Geotechnical Exploration, Inc.

Job No. 10-9977

Subject: **Response to DSD-Geology Comments**
The Reserve – Romero Subdivision
Romero Drive
APN 352-300-11-00
La Jolla, California

Per your request as required by the DSD Geology reviewer, we are responding to the following issues presented in project issues report PRJ-1063767 dated November 14, 2022.

Figure No. IIII
Job No. 10-9977.1

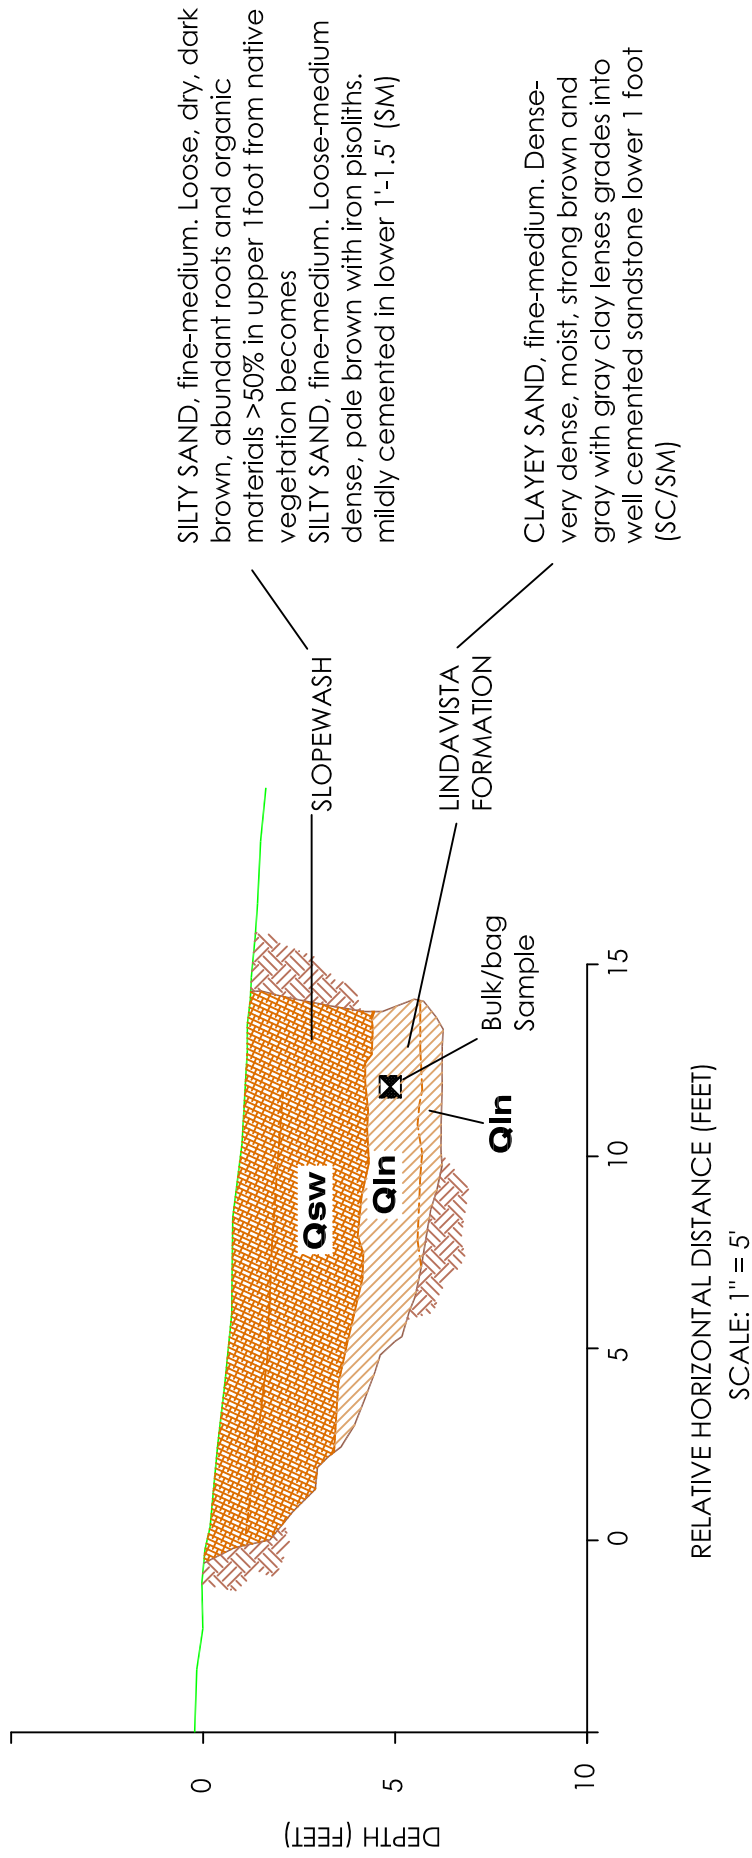
DSD-Geology Comment 00064|Page: Exploratory Trench T-6, Figure IIIIt appears to show offset in the undifferentiated Scripps Formation/Ardath Shale across the gap in the trench log at the chain link fence. Clarify why this offset is not evidence of faulting.

GEI Response: Although it might suggest offset in the undifferentiated Scripps Formation/Ardath Shale formational materials (Tsc/Ta) across the gap in the trench log at the immovable fire road fence as presented in our previously prepared exploratory trench T-6 (Figure No. IIIIt), there is not enough supporting evidence to justify designating the topsoil-slopewash (Qsw) and slopewash-fill soil (Qaf) apparent contact offsets across the trenching gap as being due to fault offset.

The apparent cross gap differential of the fill soil-slopewash contact is the same as the slopewash-topsoil contact. There have been no seismic events in the San Diego area that would have offset recently placed fill soils. No jointing or high angle breakage of the undifferentiated Scripps Formation/Ardath Shale formational materials (Tsc/Ta) that would normally be associated with faulting was observed on either side of the trench gap. Strike and dip attitudes of the undifferentiated Scripps Formation/Ardath Shale formational materials (Tsc/Ta), which had very well-defined bedding, were consistent for the full 135-foot length of the trench, including across the 5-foot trench log gap.

In summary, we conclude that the contact elevation differentials across the trench gap are not due to faulting but are a topographic feature with slightly steeper ground surface inclinations descending from the east more than the west, toward the centerline of the trench gap.

We note that we observed a drafting error in the numbering for the referenced exploratory trench T-6 (Figure No. IIIIt). The correct figure number for the original exploratory trench T-6 figure should be Figure No. IIIj. Please see that the correction has been made in the attached "Report of Geotechnical Investigation -Third Update" The Reserve – Romero Subdivision, dated October 14, 2022 (Appendix A) with reference to the original geotechnical investigation field work.
